Final Environmental Impact Statement

**REMEDIAL ACTIONS AT THE FORMER  
CLIMAX URANIUM COMPANY  
URANIUM MILL SITE  
GRAND JUNCTION, MESA COUNTY,  
COLORADO**

DECEMBER, 1986

**FIGURE 4.16**  
**MAJOR HIGHWAYS IN THE VICINITY OF GRAND JUNCTION**

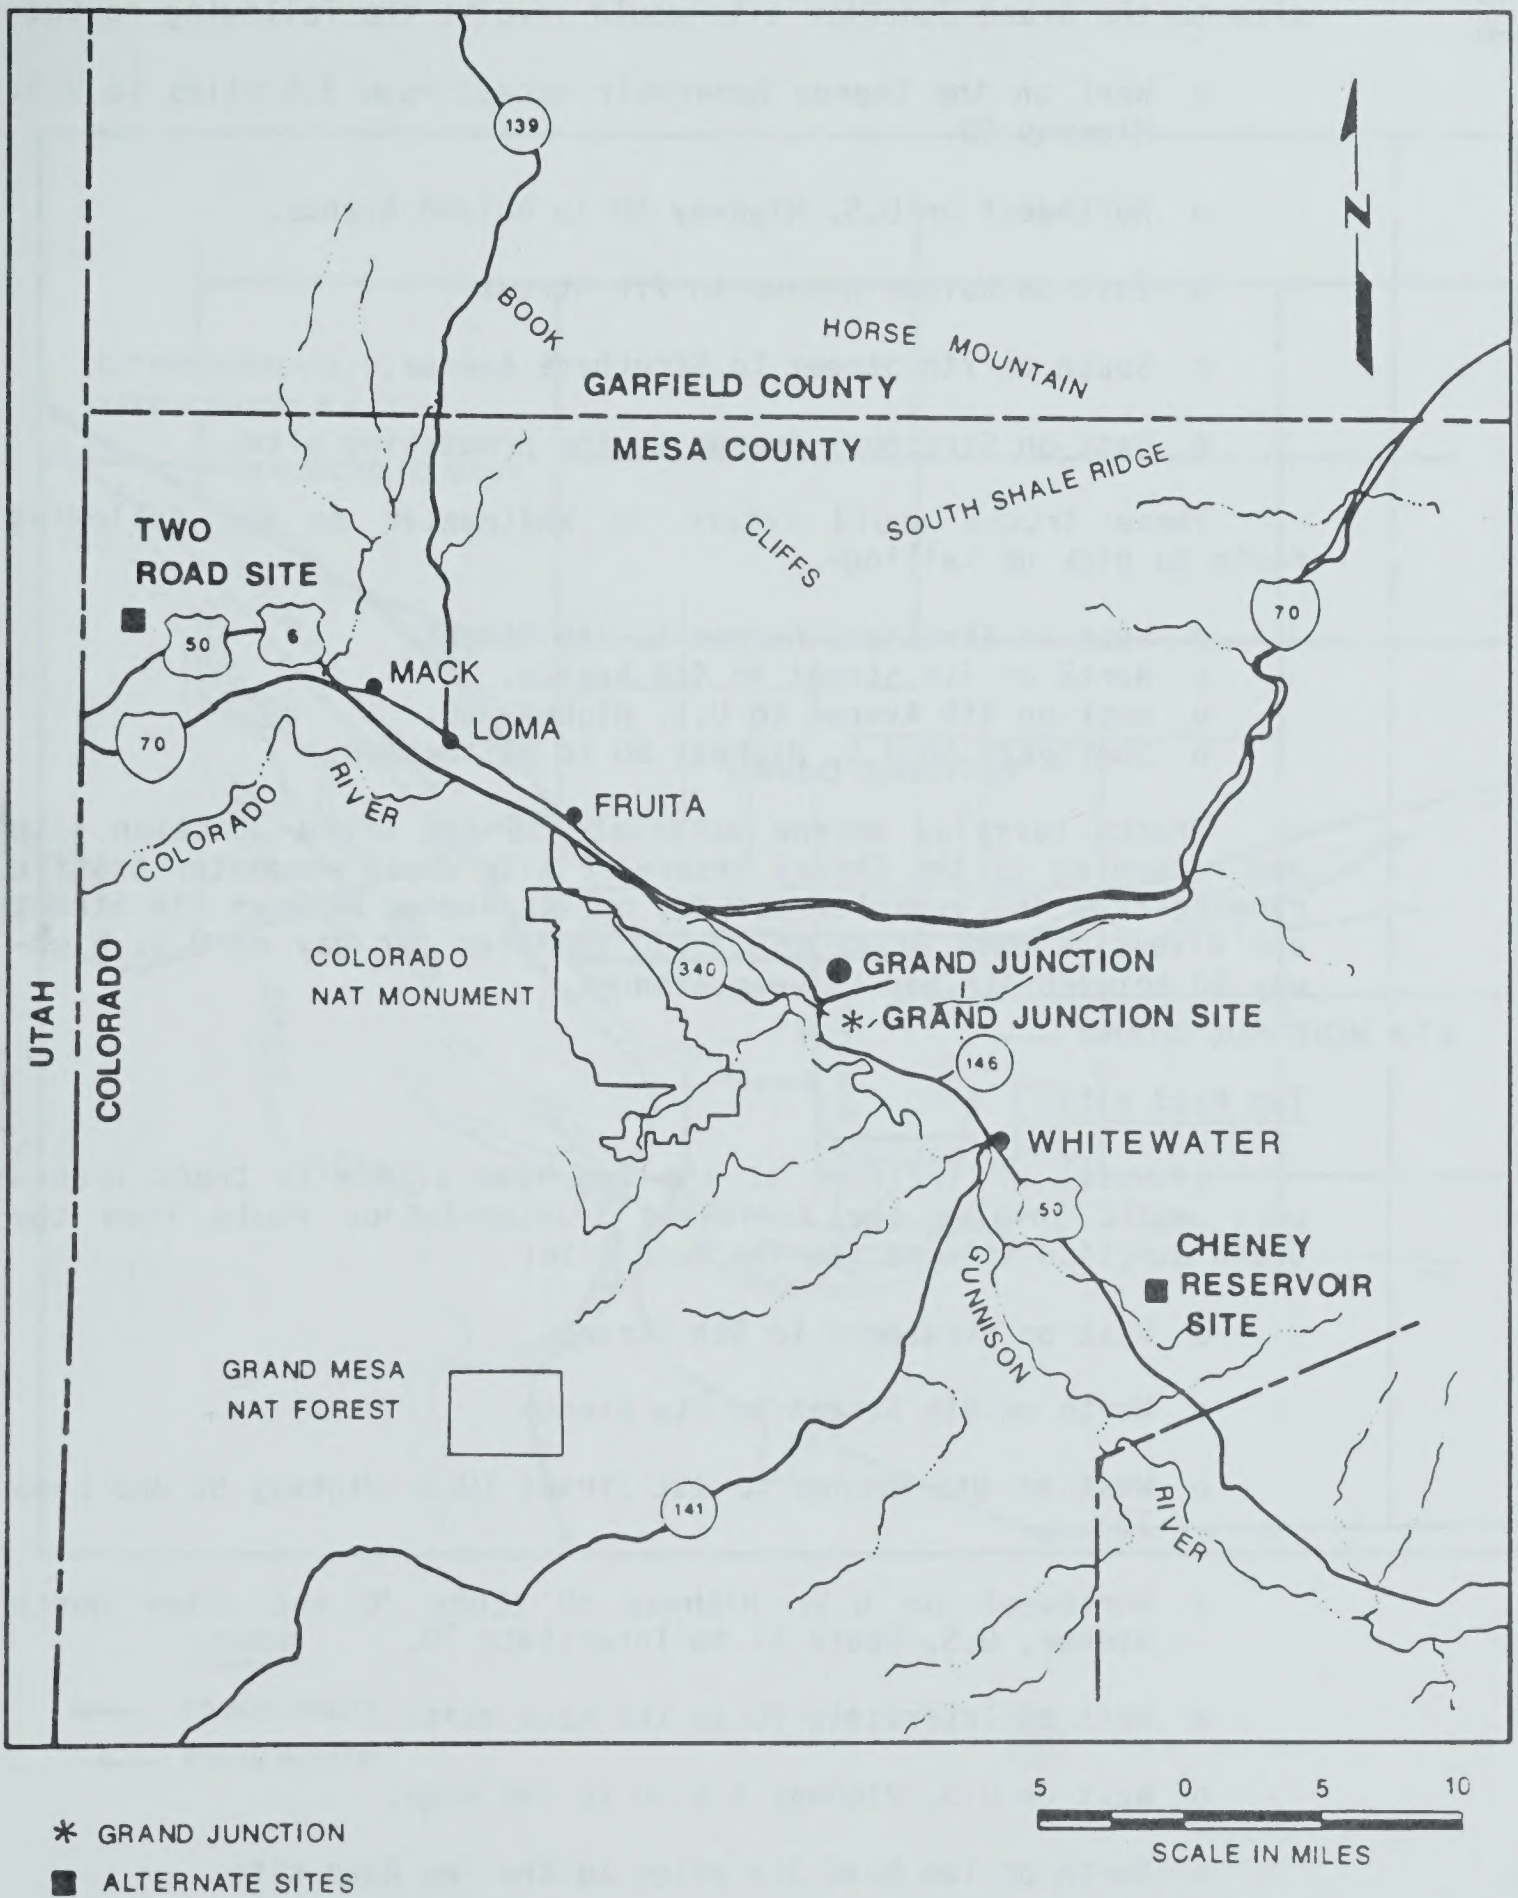
Figure 4.16. 32 Road is mislabeled; State Highway (SH) 146 is now designated as SH 141; 29, 30 and 31 Roads do not cross the Colorado River (26).

Figure 4.16 has been revised.

**FIGURE 6.1**  
**LOCATION AND TECTONIC SETTING OF THE GRAND JUNCTION AREA**

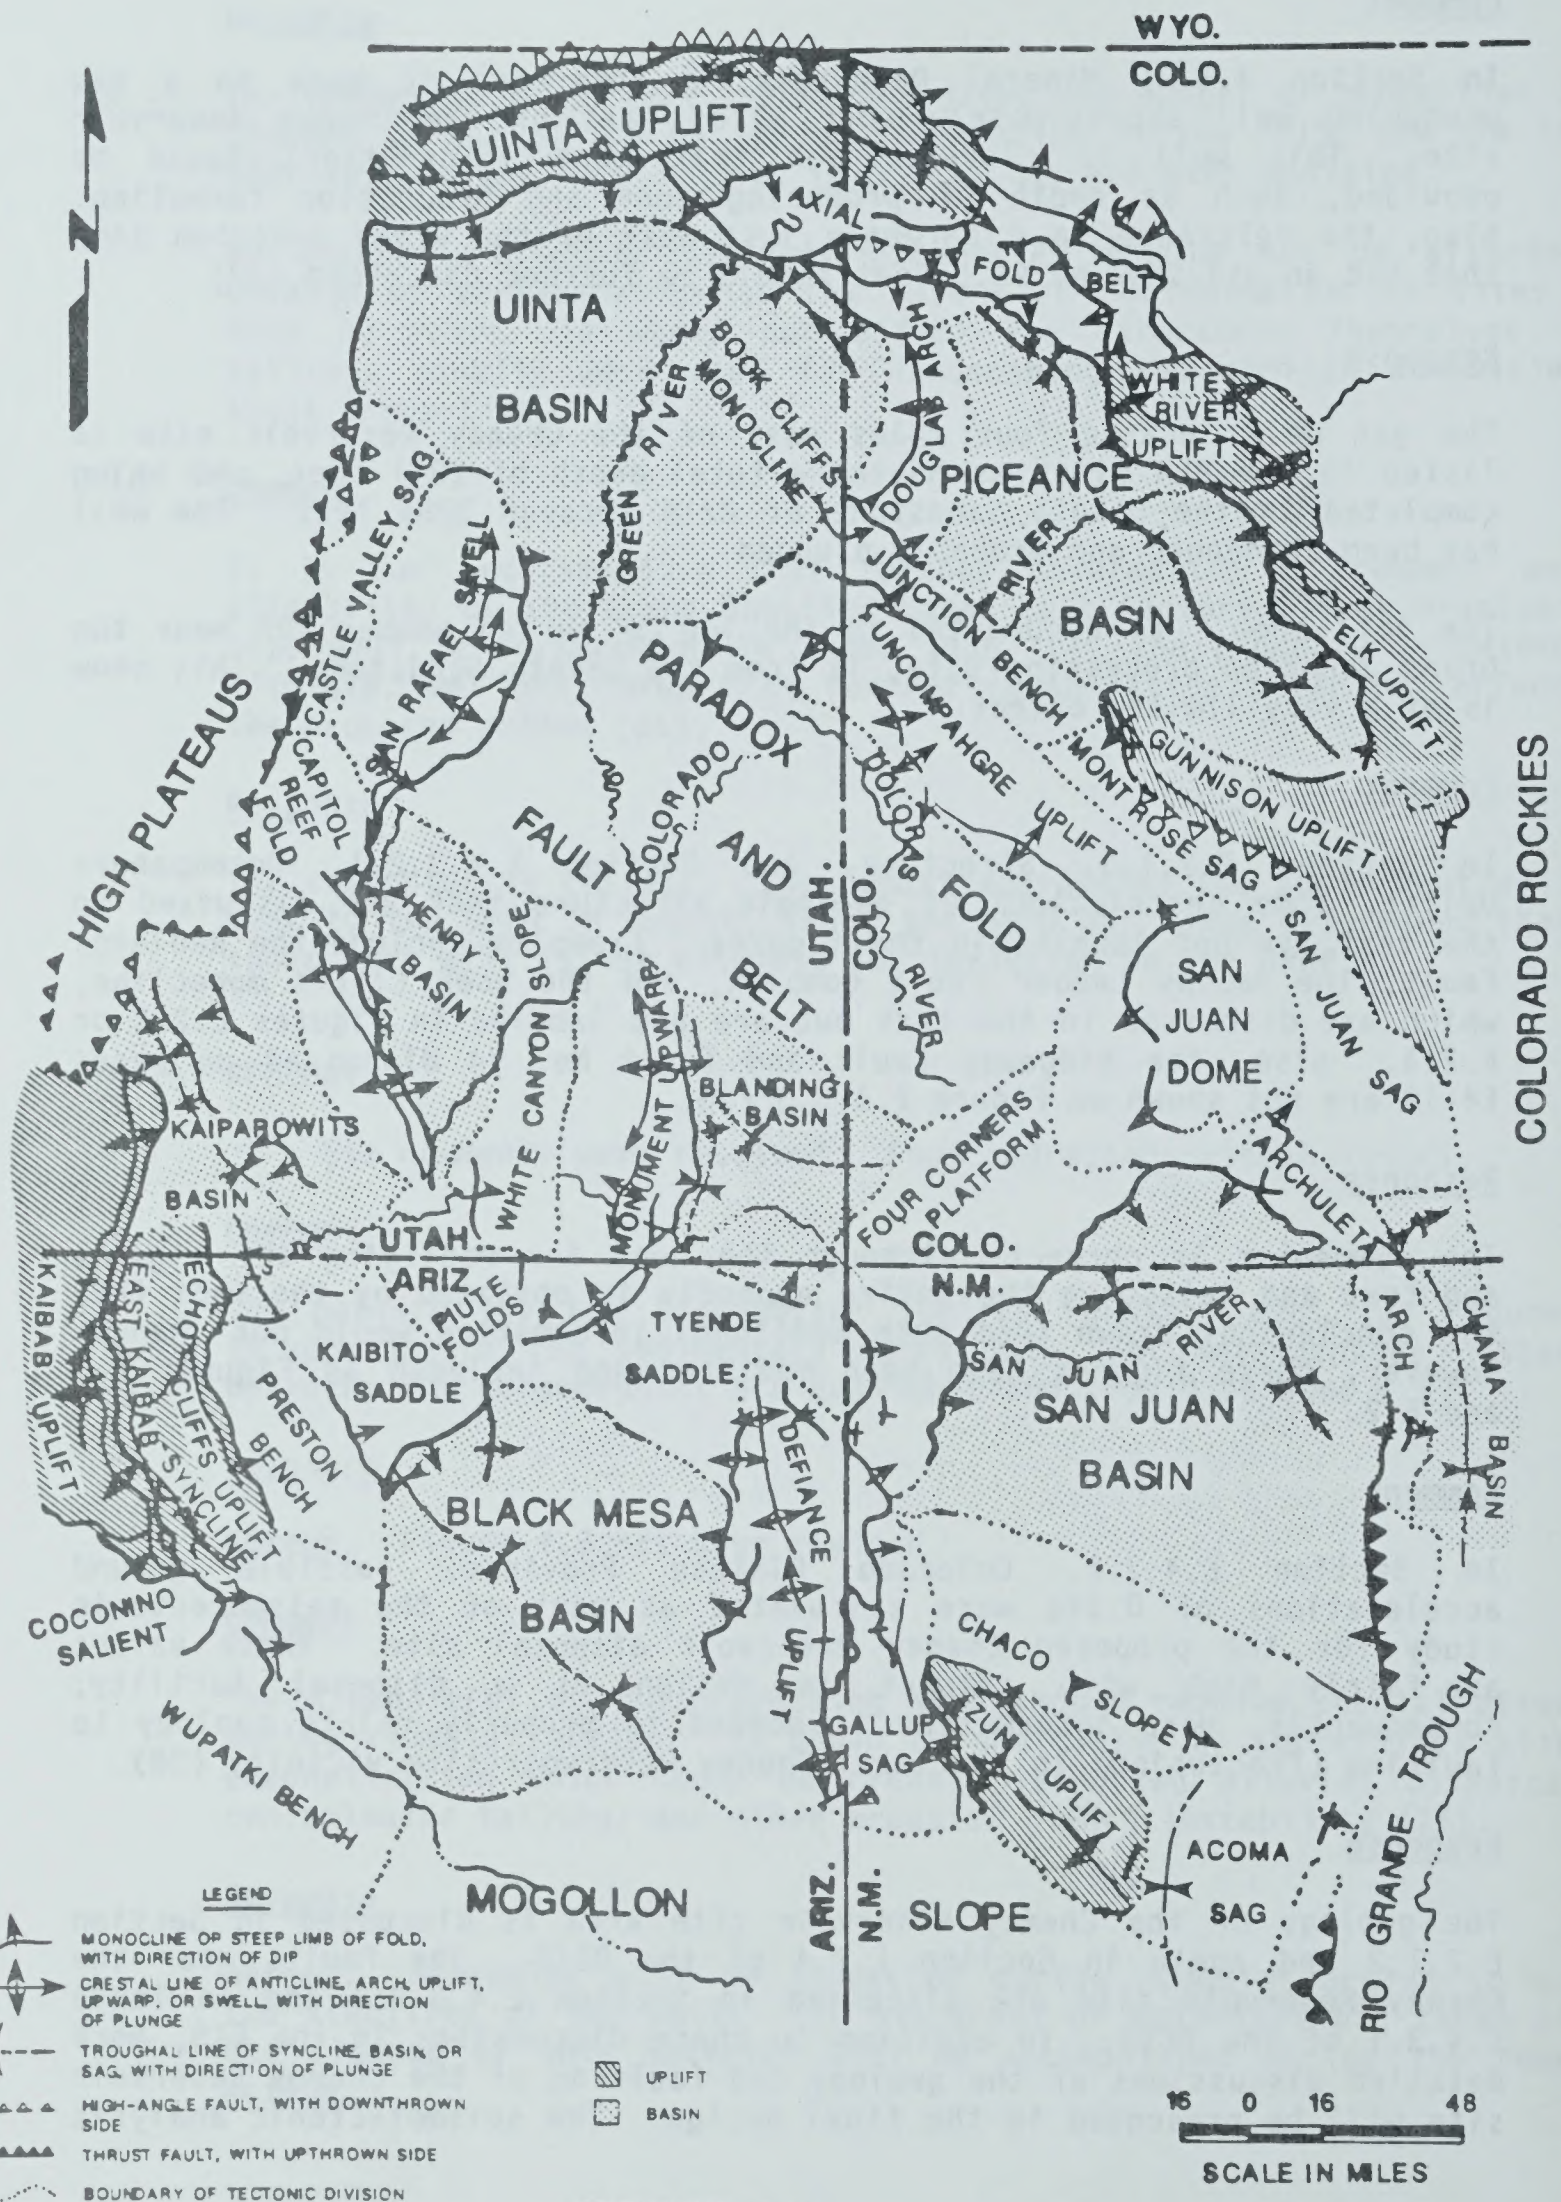
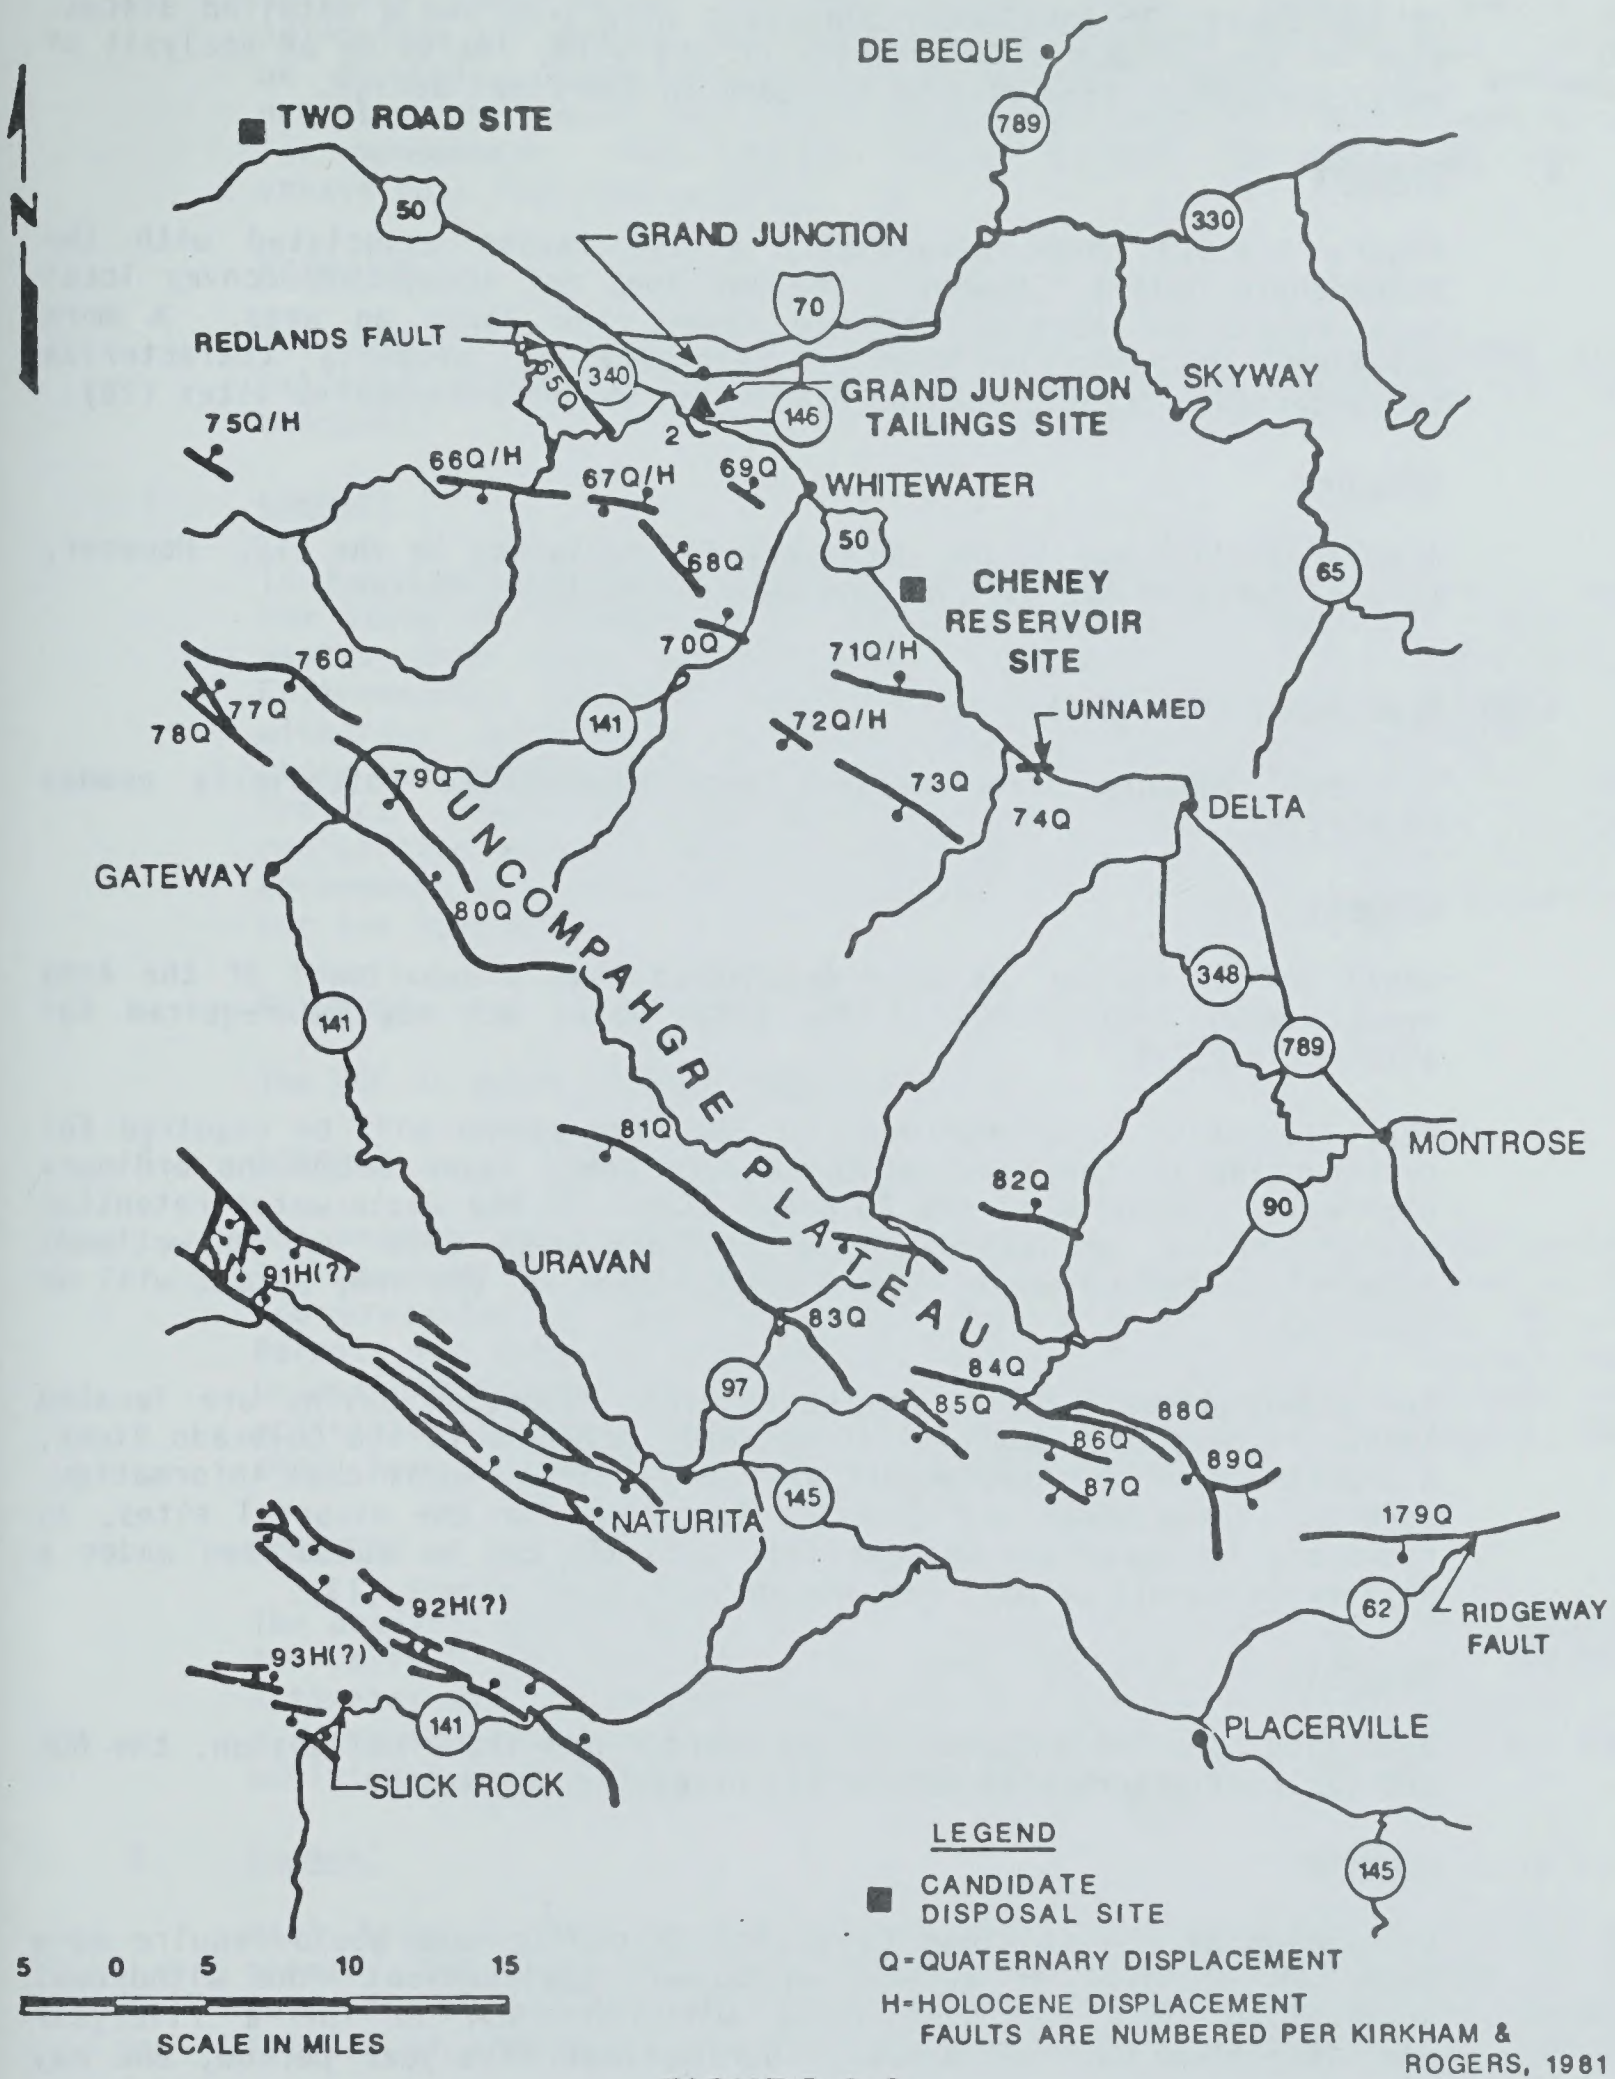
In Section E.2.1.3, Structure, and Section E.4.3.2.1, Uncompahgre Uplift, some descriptions of geologic structure that are discussed in the text are not labeled in the figures. Examples include the Redlands Fault, the Jacobs Ladder Fault complex, and the Book Cliffs monocline, which are discussed in the text but are not labeled in Figures E.2.3 or E.2.4. Also, the Ridgeway Fault and Fault No. 74 discussed on pages E4-13 are not shown on Figure E.4.3.3 (28).

Figure E.4.3.3 shows potentially active faults associated with the Uncompahgre Uplift. However, the map does not adequately convey local site conditions because the map covers too large an area. A more detailed, larger-scale map is necessary to properly characterize seismotectonic activity and/or prediction at the alternative sites (28).

The commentor is correct, although the need for modifying the figures and text and reissuing the entire appendix is obviated by the fact that the conclusions drawn from such additional information would not change. However, these figures have been modified and included as Figures 6.1 and 6.2.
